TOWN OF BAY HARBOR ISLANDS
QUASI-JUDICIAL PUBLIC HEARING AGENDA

January 13, 2020

Subject: Zoning Variance Application
Daryl & Meital Eber
1250 102nd Street / Lot 4, Block 25
Allow Shed in Eastern Side Yard Setback
Planning & Zoning Comments
MMPA Project No.01-0702-0500B

Subject: Sign Variance Application
Applicant - SGM, LLC
1048 AB Kane Concourse
Lot 7 Less the North 15 Feet of Block 12
Planning & Zoning Review Comments
MMPA Project No.01-0702-0500B

ZONING PLANS REVIEW WORKSHEET

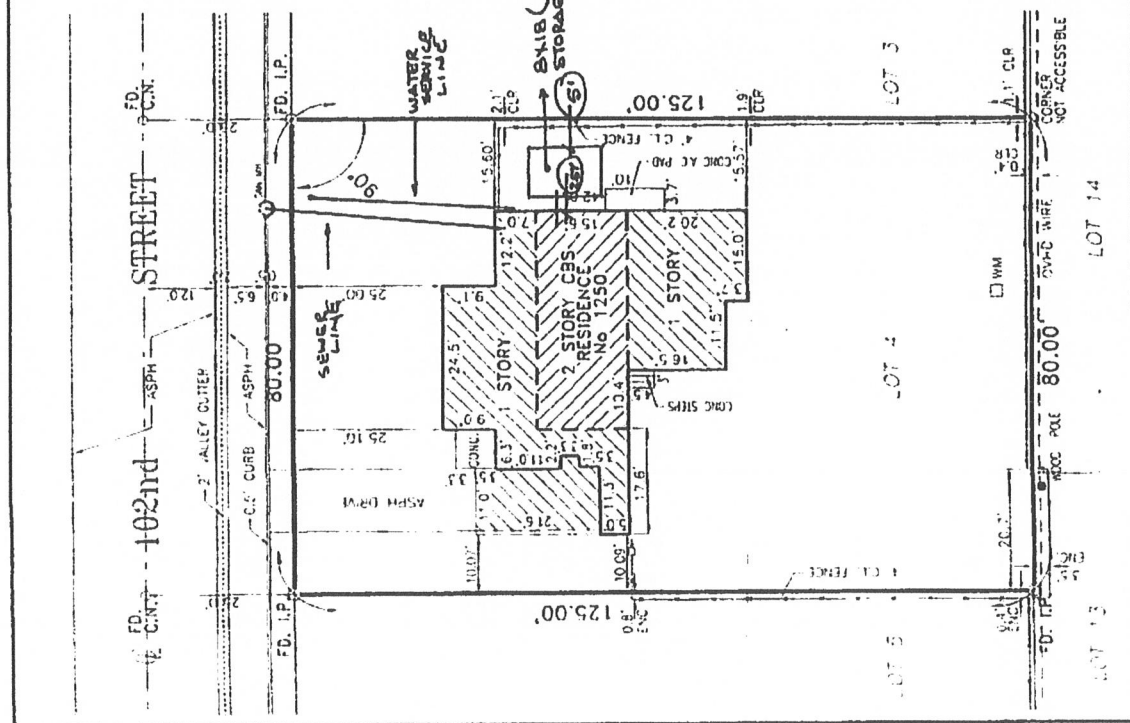
1) SURVEY (NO ~~THE~~ more than 6
months old) Survey dated 8/20/2002

2) Provide AMOUNT OF PREVIOUS
AREA (Green space) SQUARE
FOOTAGE

3) THE SIDE SETBACK IS A
MIN. 10'. THE SHED IS NOT
PERMITTED IN THE PROPOSED
LOCATION. THE BACK YARD
HAS ROOM TO MEET SETBACKS.
REAR SETBACK
15' MIN.

Town of Bay Harbor Islands
1048 Kane Concourse

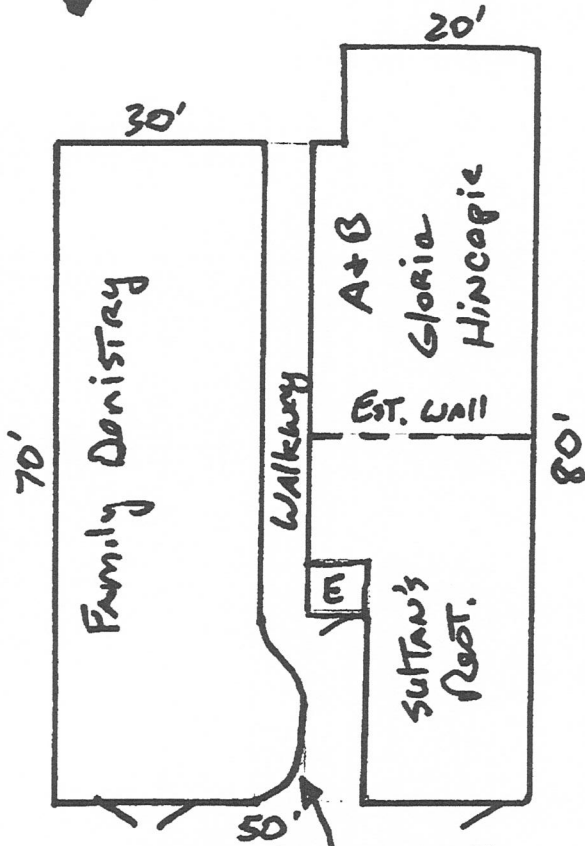
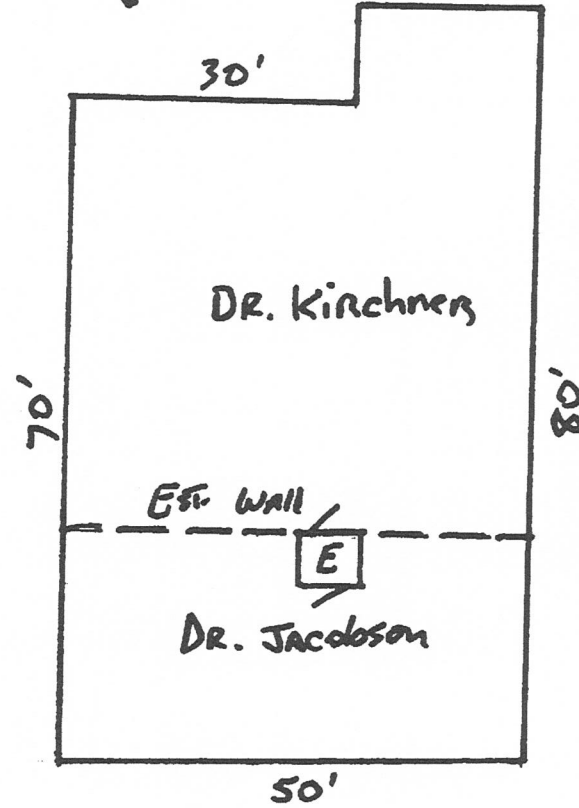
in the correspondence. Had the new tenant's bay location been disclosed (A&B) facing the atria / alley the MMPA employee's response would have been different. More research should have been done on the status of the Dr. Jacobson sign by MMPA staff – Town staff knew it was an illegal sign, but the Town allowed it to remain. Our conversations within the MMPA offices about this request revolved on replacing Dr. Jacobson's sign with a tenant sign in the same location. The Sign Code is clear that tenant spaces that do not have street frontage (upper floors / internal bays / rear bays) cannot have a business sign on wall surfaces facing a street. They can have other signs (window / door / directory / sign facing an alley).

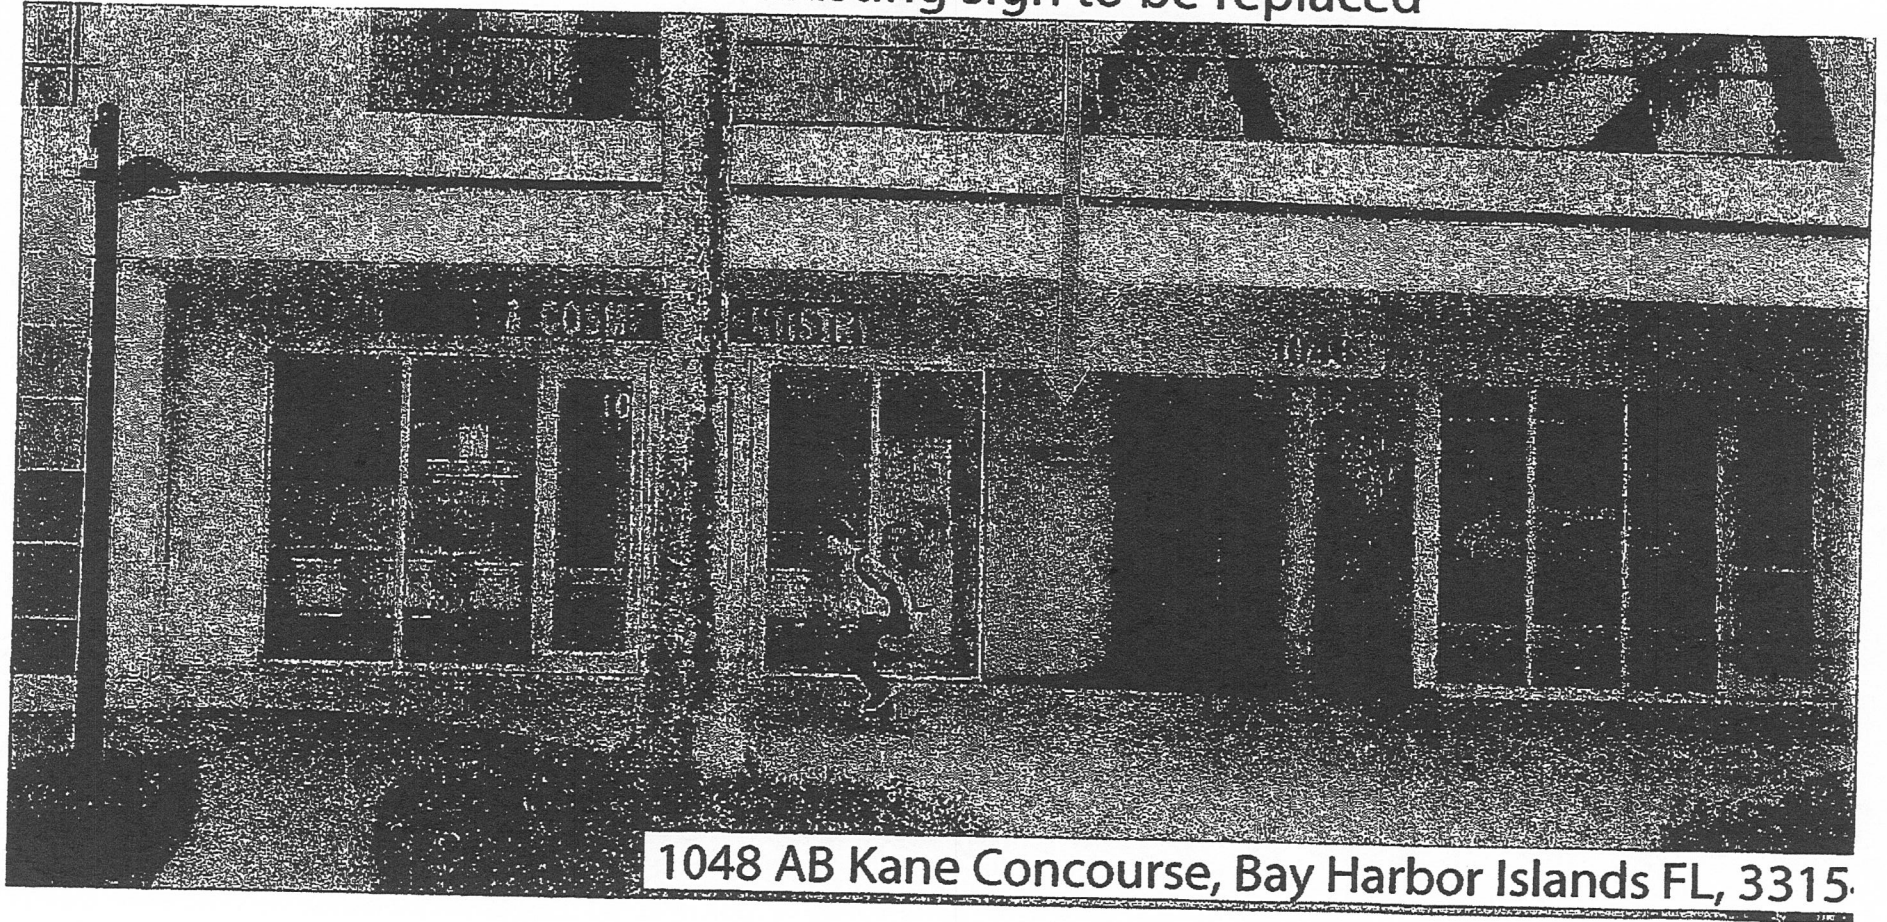
- a) A single color sign for entire complex
is required. Existing signs are
"Blue" - proposed is "Gold" See 17-20(d)
- b) min LTR thickness is 1/2" (shows 1/4") See 17-20(d)
- c) need floor plan to demonstrate
bay on ground floor (do not see bay)
- d) need BTR prior to sign approval

ALUMINUM LOGO - LETTERS
 COLOR: GOLD
 NORTH ELEVATION

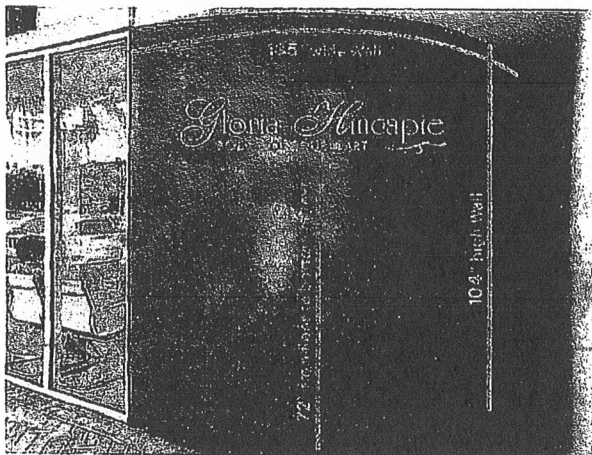
1. Denied - Plan design violates sign code 2. A single color sign for entire complex is required. Existing sign is "Blue"
- Proposed is "Gold" Sec 17-20(d) 3. Minimum letter thickness is 1/2" (shown 1/4") Sec 17-20(e) 4. Need floor plan
to demonstrate bay are on ground floor (do not see bay in photo)
